# City of San Antonio

Re: **Point Vista Subdivision**

**MDP # 025-07**

POINT VISTA SUBDIVISION  
 MASTER DEVELOPMENT PLAN  
 M.D.P. # 025-07  
 DATE: 6/22/2007

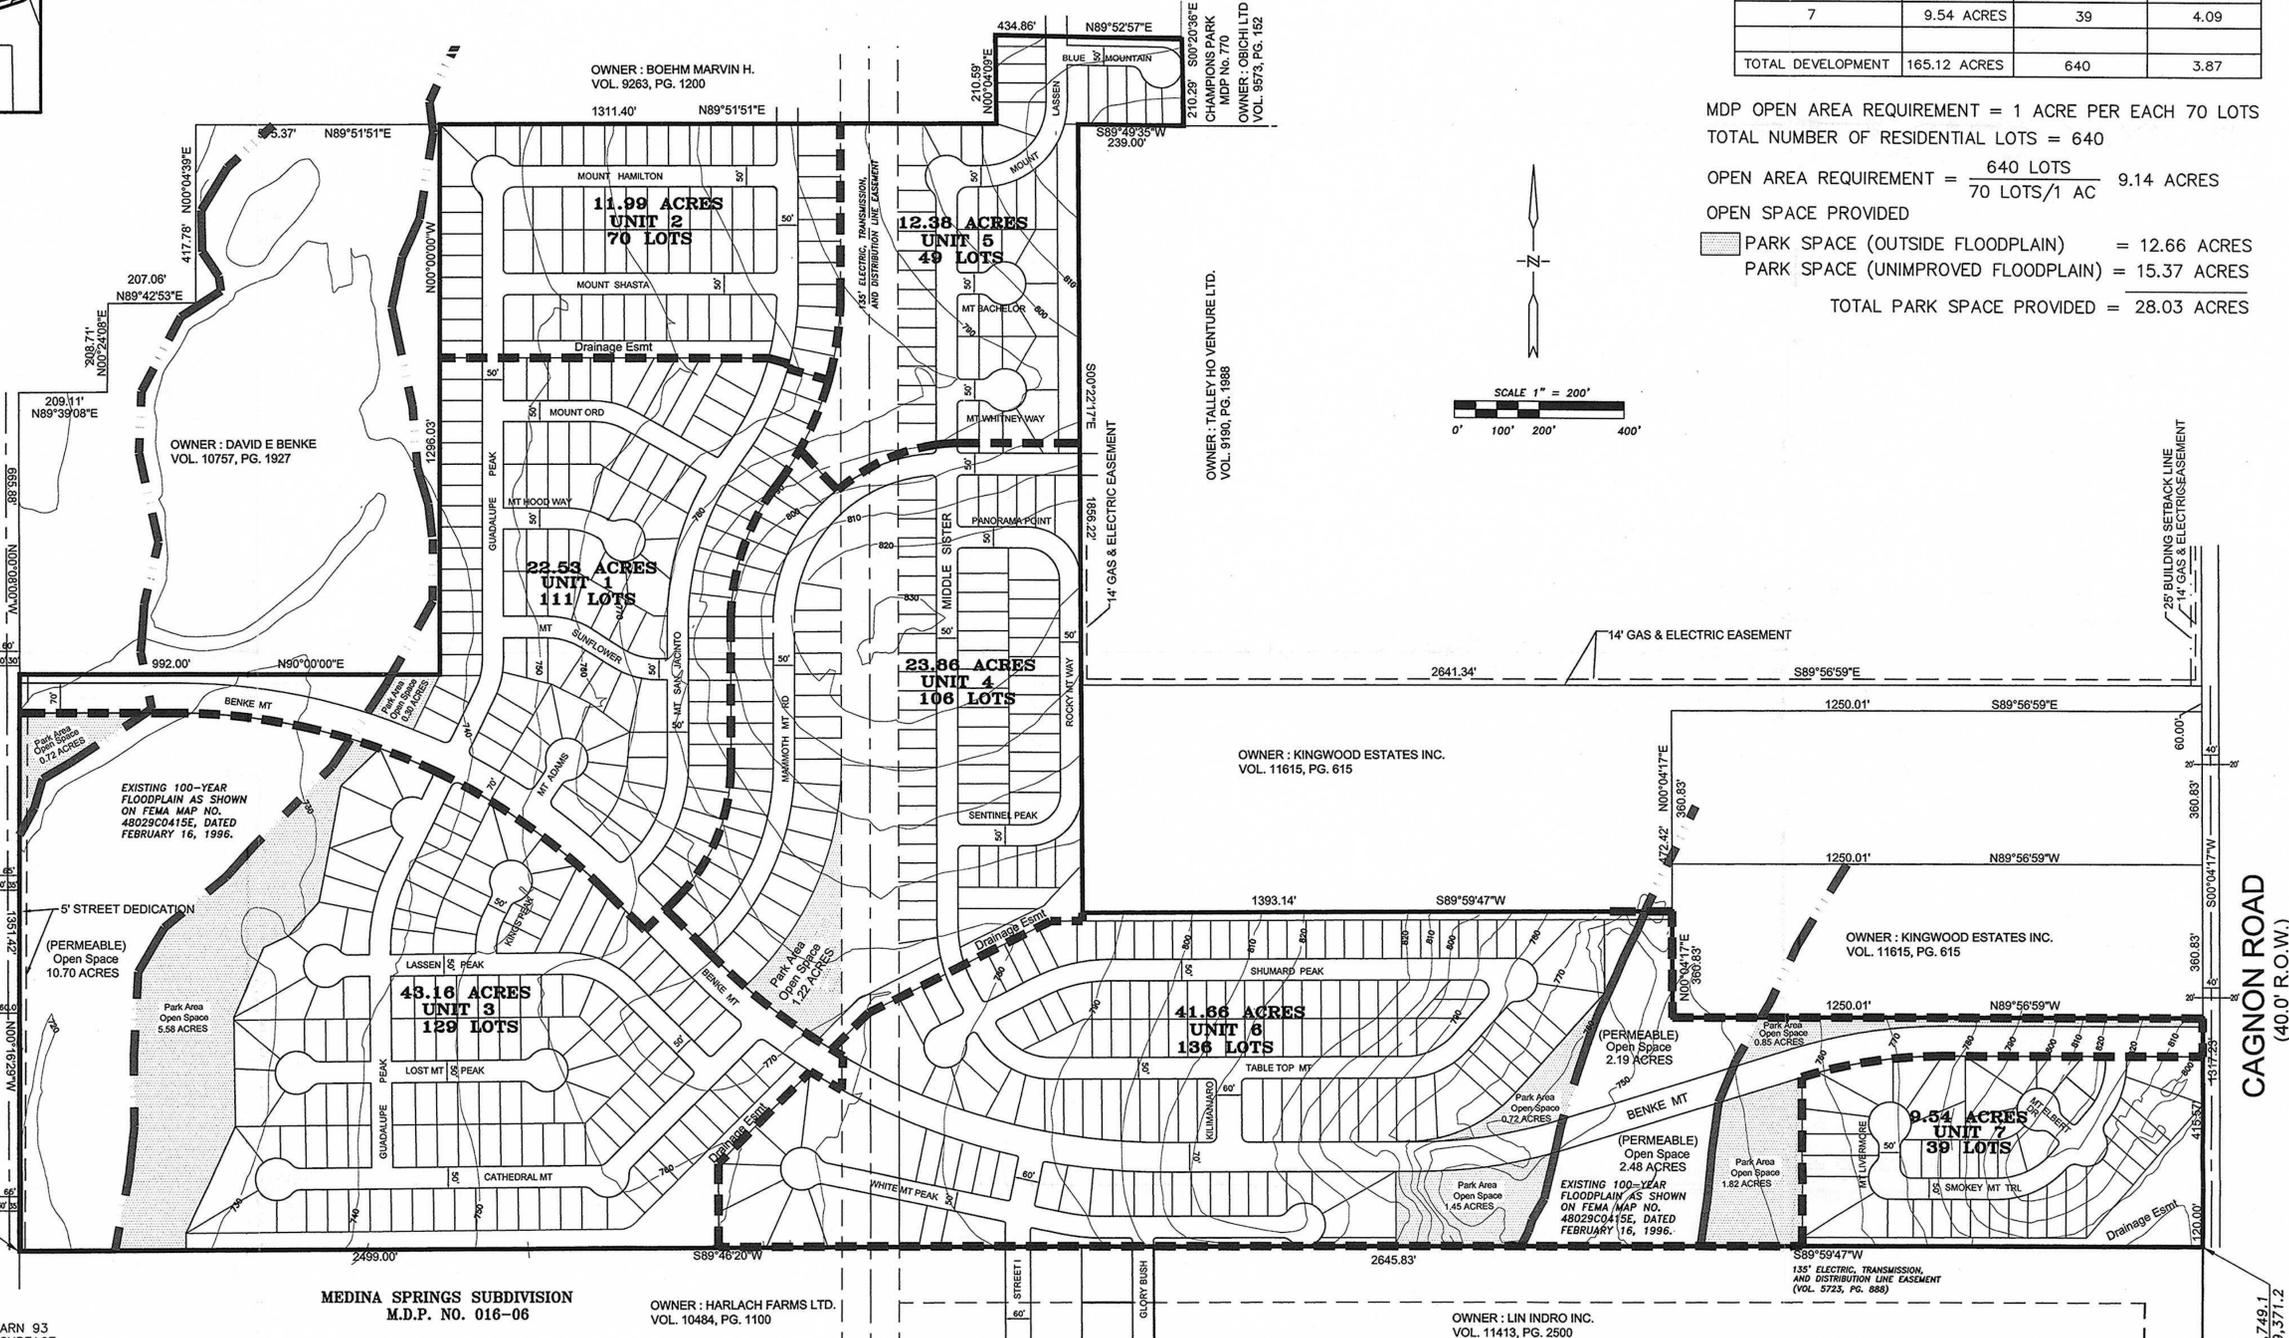
In consideration of public safety and convenience, excessive grades by reason of topography should be avoided in street layouts and arrangements. Any access and R.O.W. issues along state facilities will need to be resolved with the **Texas Department of Transportation (TXDOT)**. For information about these requirements you can contact TXDOT at (210) 615-5814.

The DSD – Traffic Impact Analysis & Streets Division has reviewed the Level – 2 Traffic Impact Analysis (TIA) and the MDP plan for Point Vista Subdivision. The analysis indicates compliance with TIA Ordinance 91700 and the UDC and has no additional comments to return to the engineer.

- All roadways shall follow Table 506-7, Functional Classification System Description and shall comply with UDC §35-502(a) (9).
- All access roadways shall provide clear sight distance on all existing and proposed roadways in order to provide adequate obstruction free viewing distances for approaching traffic.

- All signage, landscaping, and improvements shall be selected and located so as to not block these clear sight distance areas.
- The developer shall be responsible for providing a right-turn deceleration lane at the two proposed entrances, with storage length and bay taper per TXDOT design standards as it relates to the submitted TIA traffic counts, (Uniform Development Code (UDC) - §35-502 (a)(7), subsection C.

- Dedicate 70-feet of ROW and construct a 4-lane undivided roadway.
- Sidewalks along all interior and exterior roadways are to be installed in accordance with UDC §35-506(q).

- Developer shall dedicate 5 feet along Grosenbacher.

- Streetscape standards per UDC §35-512 - The new ROW on Benke Mt. (collector) will require streetscaping as well (we recommend preservation of existing trees where available and possible).

- A right-turn deceleration lane will be required for access to Grosenbacher Road through separate permit by Bexar County. UDC §35-502(a)(7)(D)
- Traffic controls shall be warranted as per the Texas Manual on Uniform Control Devices and approved by Bexar County.
- Secondary access must be constructed with or prior to the approval of any plat or combination of plats exceeding 125 dwelling units as per UDC §35-506(e) (7).
- Voluntary efforts, beyond those herein required, to mitigate traffic impacts are encouraged as a means of providing enhanced traffic handling capabilities to users of the land development site as well as others.
